South Lodge Barn
South Lodge Road, Stelling Minnis,
Nr Canterbury, Kent, CT4 6BL

Roof Plan as Proposed

Project No.	Drawing No.	Revision
18204	011	A

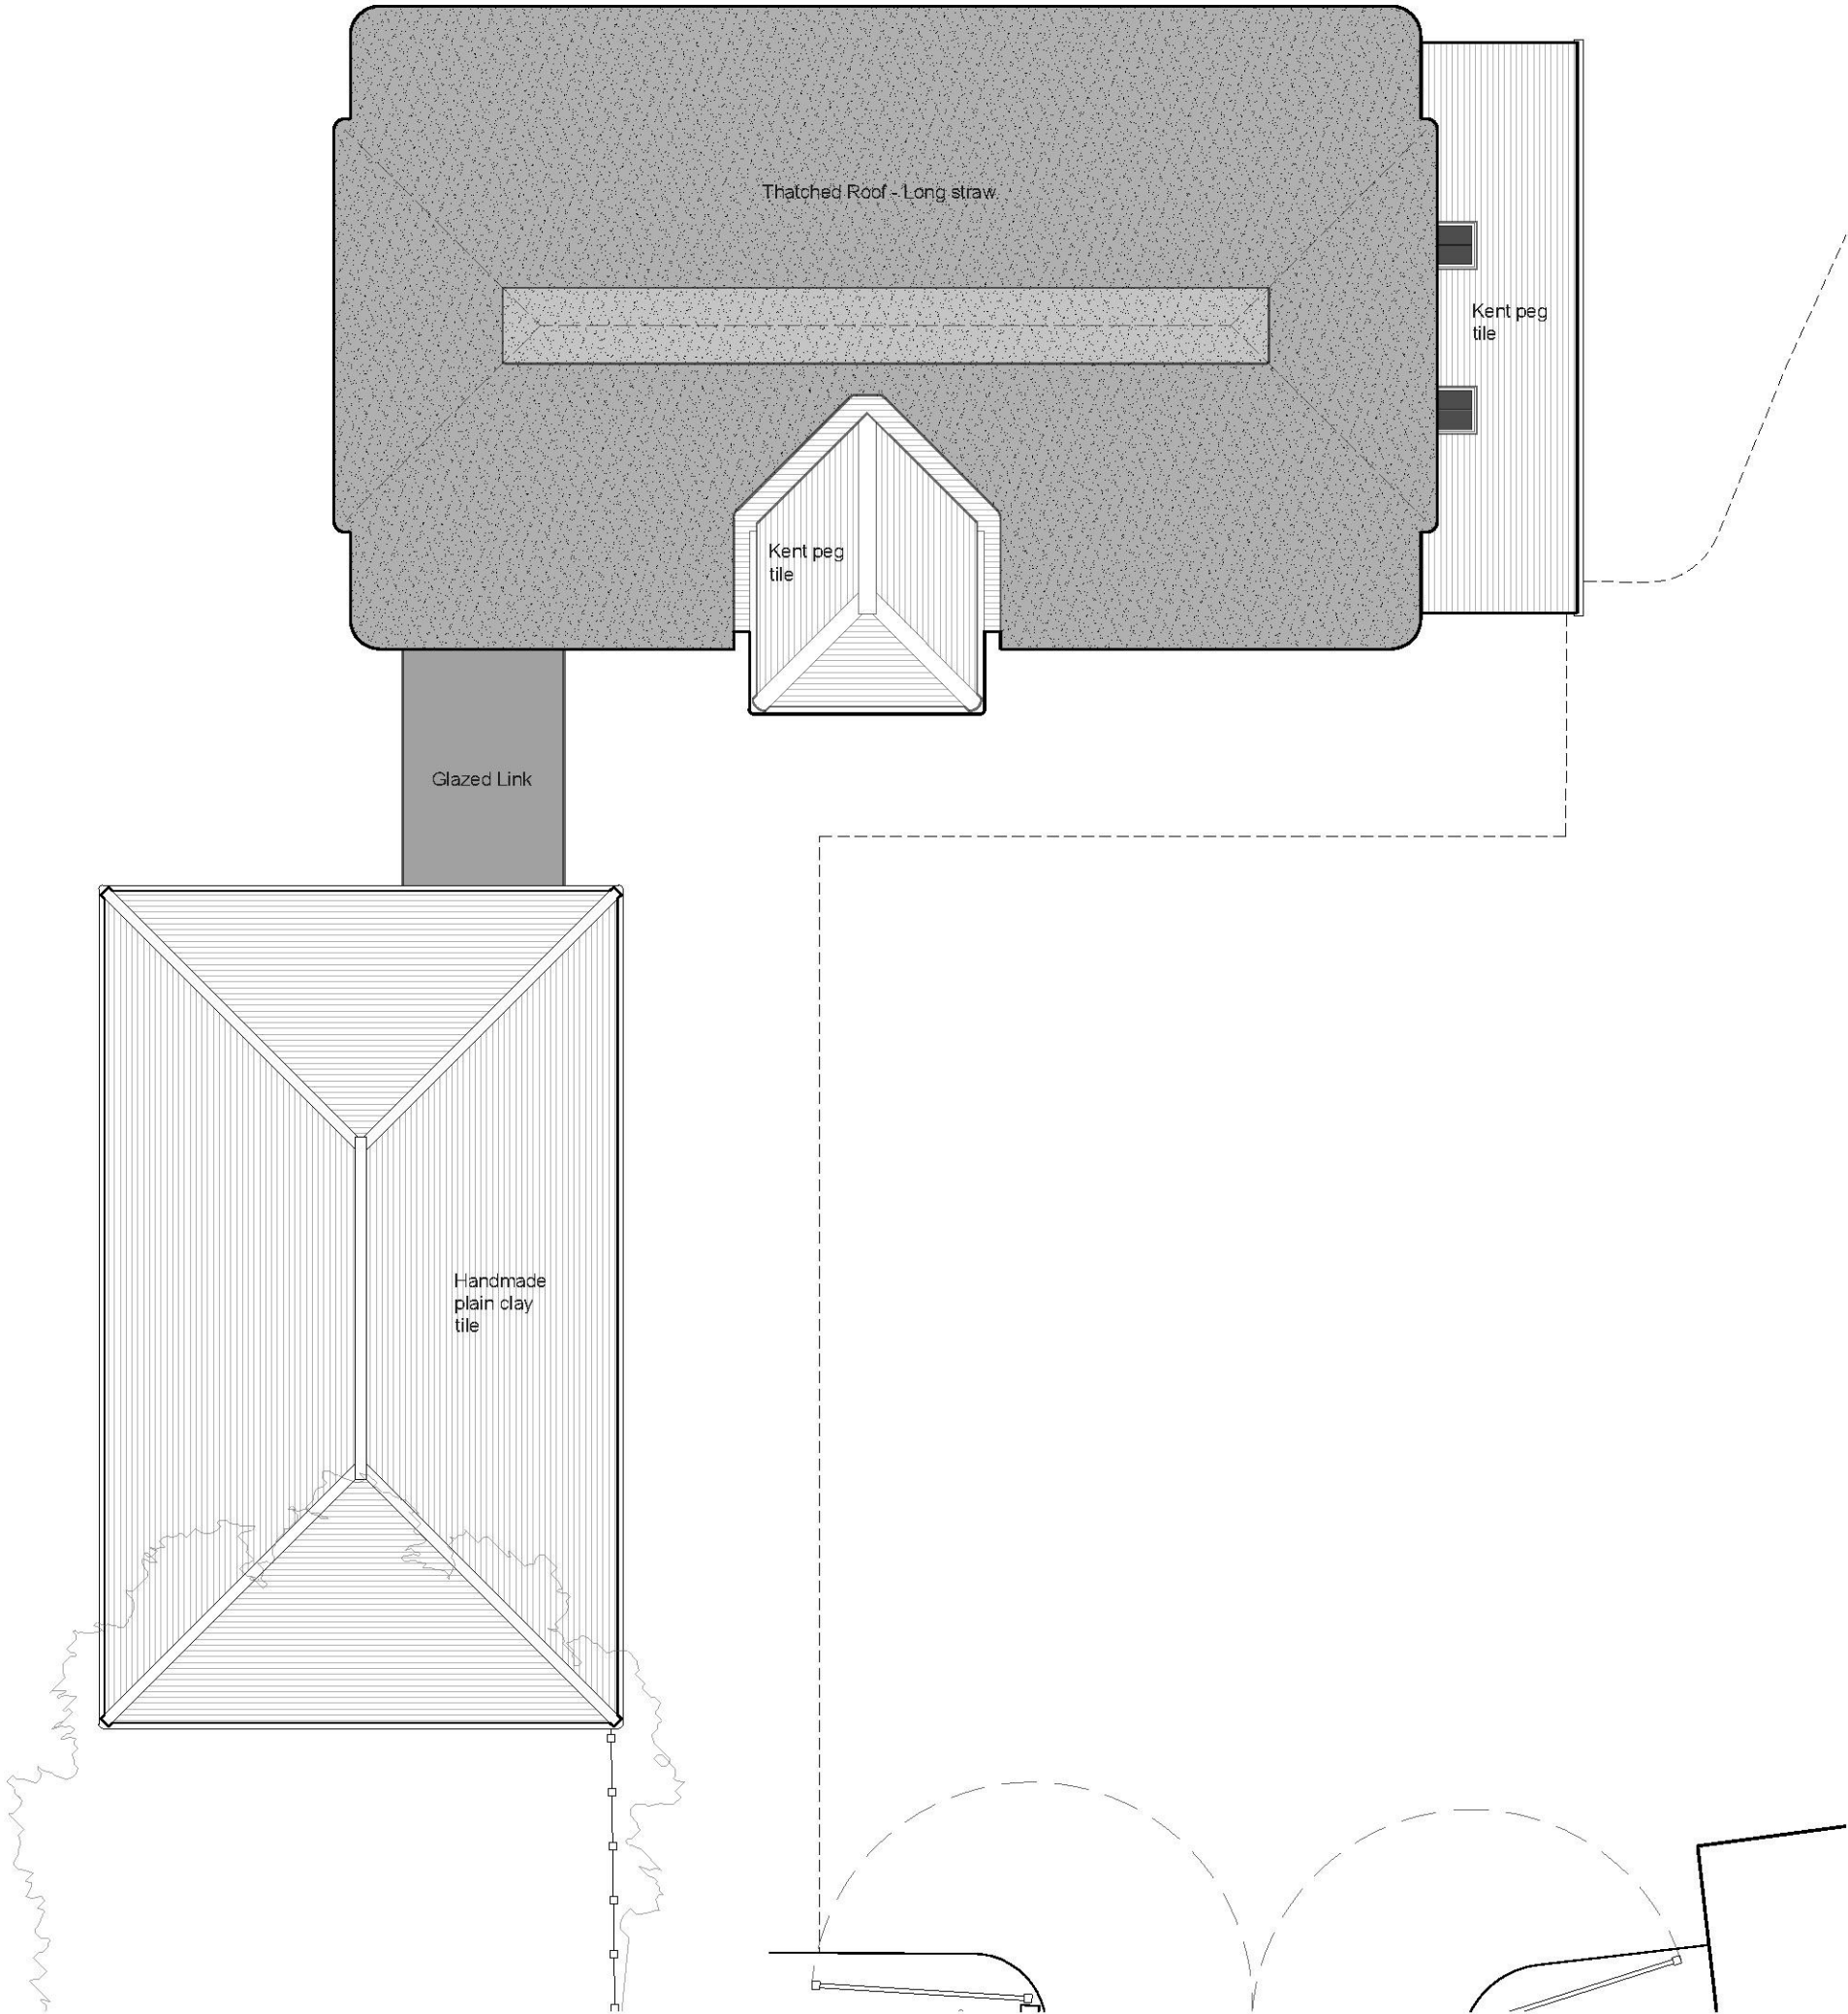
Rev.	Date	Author / Notes
A	18/12/19	SS - Roof plan revised to reflect pre-application meeting. Glazed link added. Roof lights amended in size and position.
